DOCUMENT 009113 – ADDENDUM NO. 2

- A. Project Name: Optimist Pool Bathhouse Repair
- B. Owner: City of Raleigh, Recreation and Cultural Resources/Design Development Division
- C. Architect: Osterlund Architects, PLLC.
- D. Architect Project Number: 2325.
- E. Date of Addendum: 3-1-2024.

Optimist Pool Bathhouse Repair

INTERIOR ELEVATIONS- MEN'S LOCKER ROOM

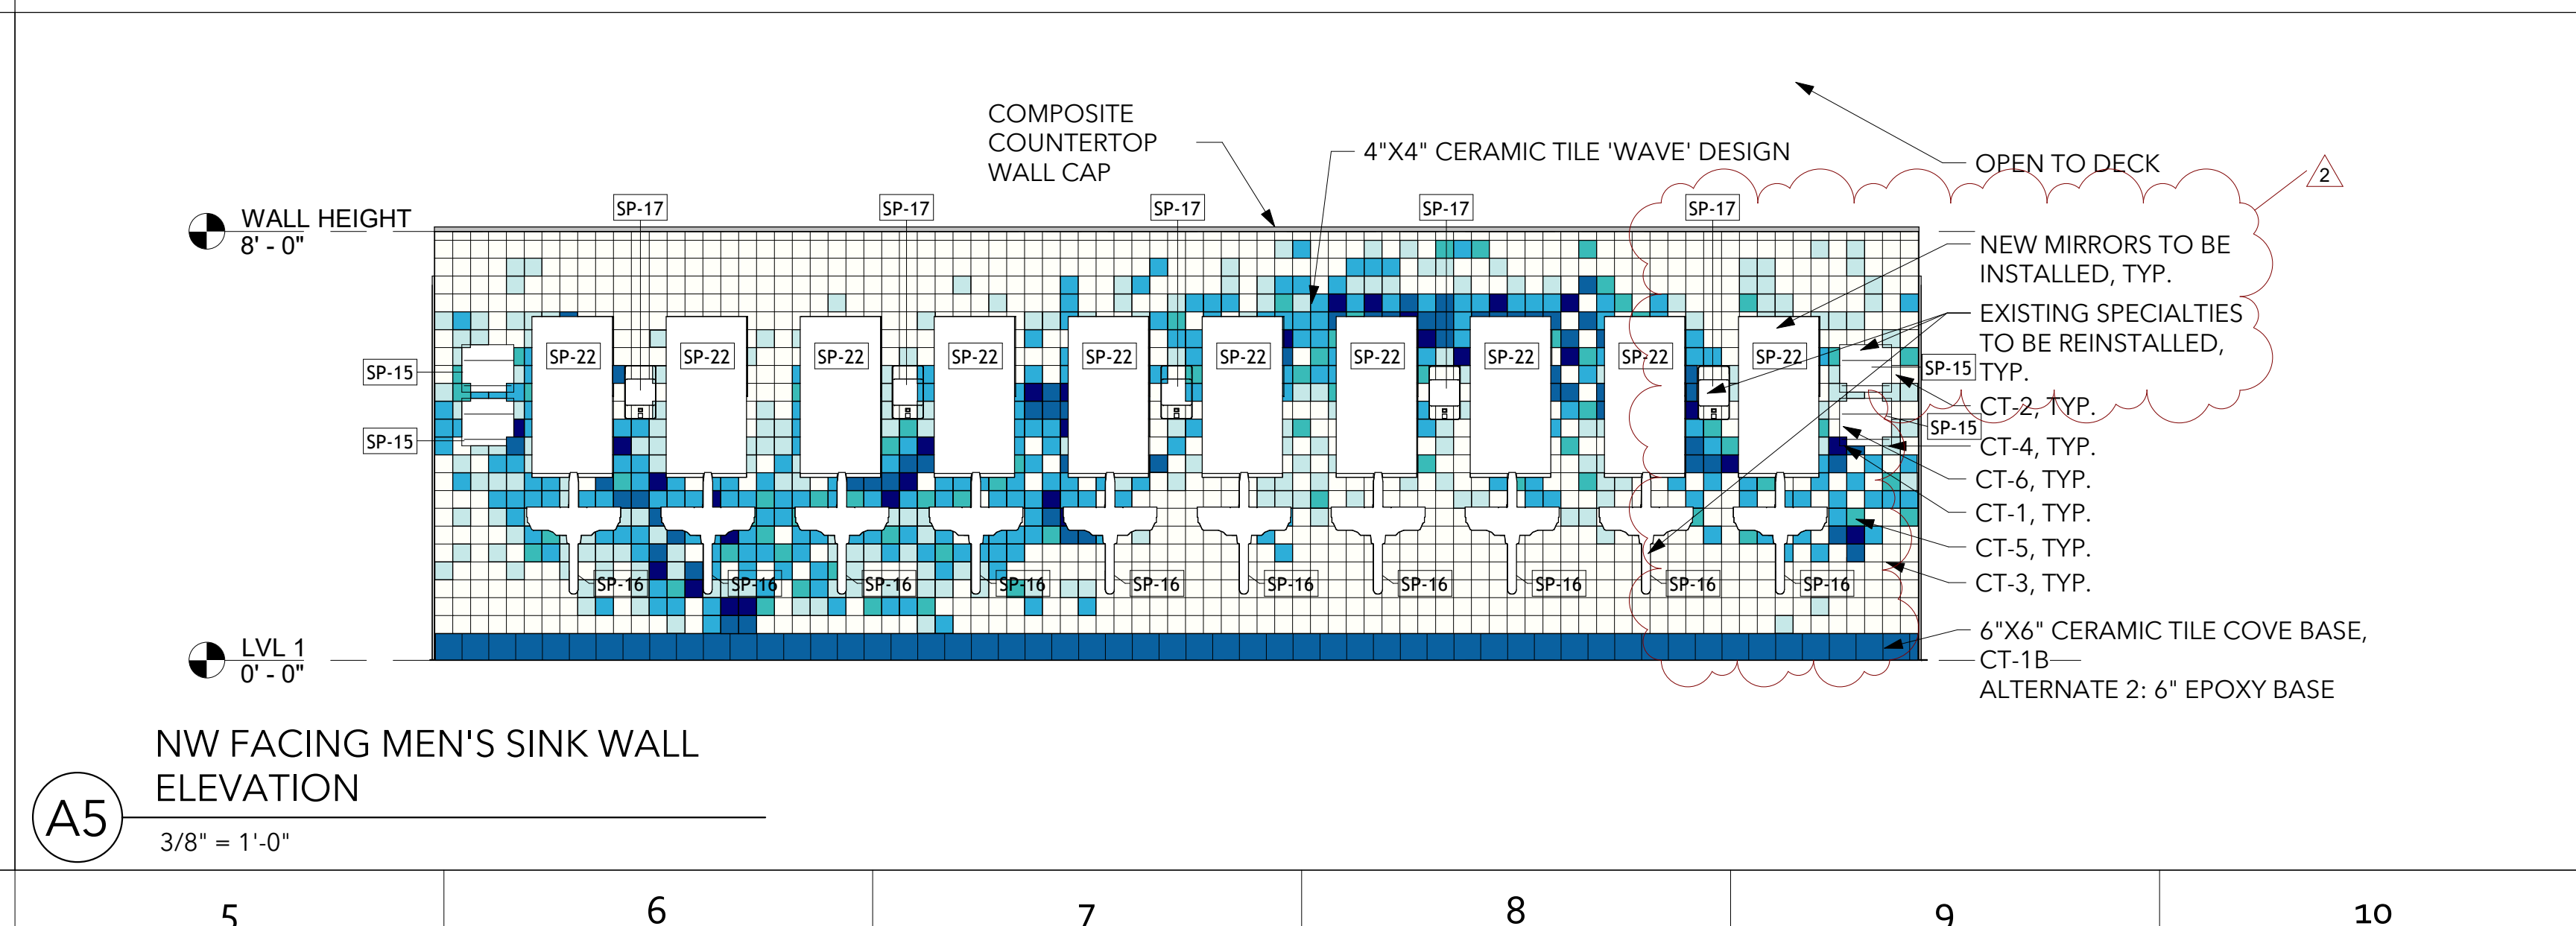
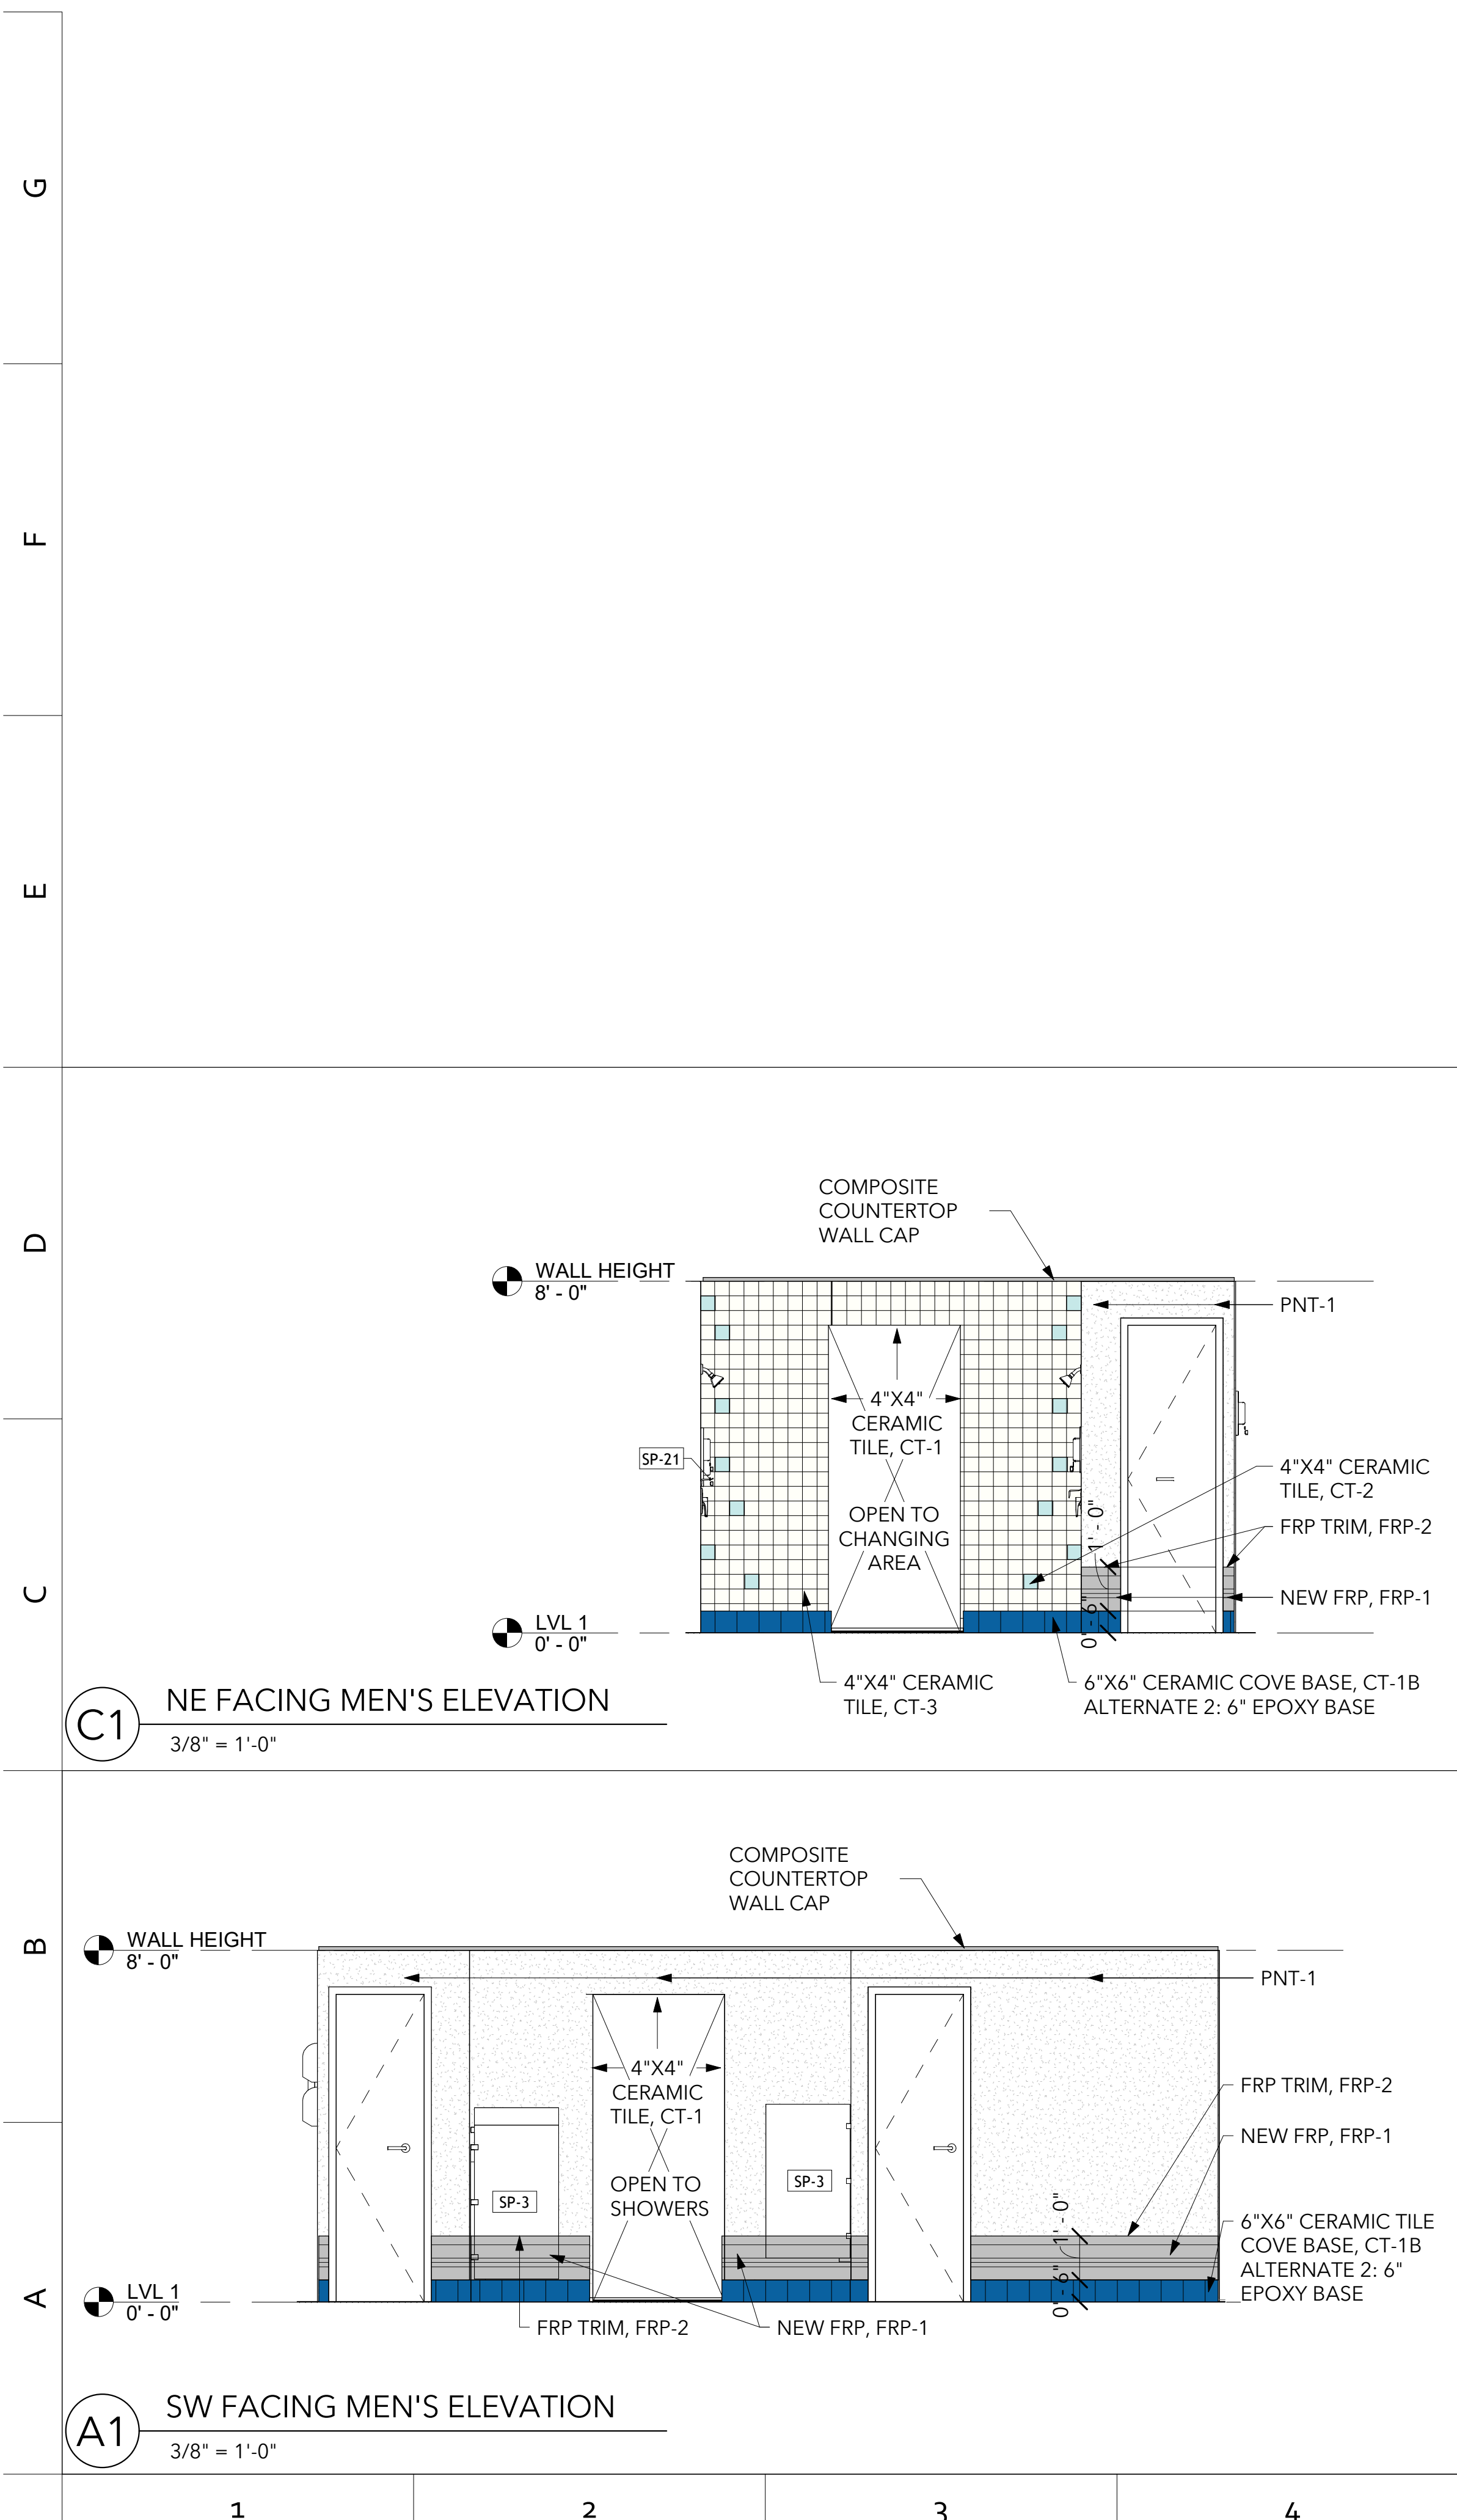
- A. This Addendum includes the following attached Documents and Specification Sections:
 - 1. Document 2325 Planholder List, dated 2-27-2024. (new)
 - 2. Document 2325 Bidder RFI Log, Dated 3-1-2024. (new)
 - 3. Document 2325 08 R2 I Sheets 03.01.24. (revised)
 - a. Revised Drawing D1-I201 to include all new mirrors instead of salvage and reinstall.
 - b. Revised Drawing A5- I204 to include all new mirrors instead of salvage and

RFI No.	Date Received	Via	Description	Response	Response Date	Addendum No.
1	2/19/2024	Email	I201 detail D1 and I 204 Detail A5 both have a note showing existing to be reinstalled pointing to SP-22 (mirrors)	Mirrors are all to be new, purchased and installed by GC.	2/22/2024	2
2	2/19/2024	Email	I 601 shows SP-22 Mirrors as new and by GC.	Mirrors are all to be new, purchased and installed by GC.	2/22/2024	2
3	2/19/2024	Email	Are mirrors to be removed and reinstalled per elevation or new per schedule?	Mirrors are all to be new, purchased and installed by GC.	2/22/2024	2
4	2/21/2024	Pre-Bid Meeting	Are Bid Bonds or P&P Bonds Required?	Bid Bond is required over \$500,000; P&P is required over \$300,000	2/21/2024	2
5	2/21/2024	Pre-Bid Meeting	Will Conex be required during construction?	Yes, Conex will be required. Hallway will be available for storage but only after June 13, 2024	2/21/2024	2
6	2/21/2024	Pre-Bid Meeting	What is the age of the building? Is asbestos a concern?	Building was built in 2008, no hazmat required.	2/21/2024	2
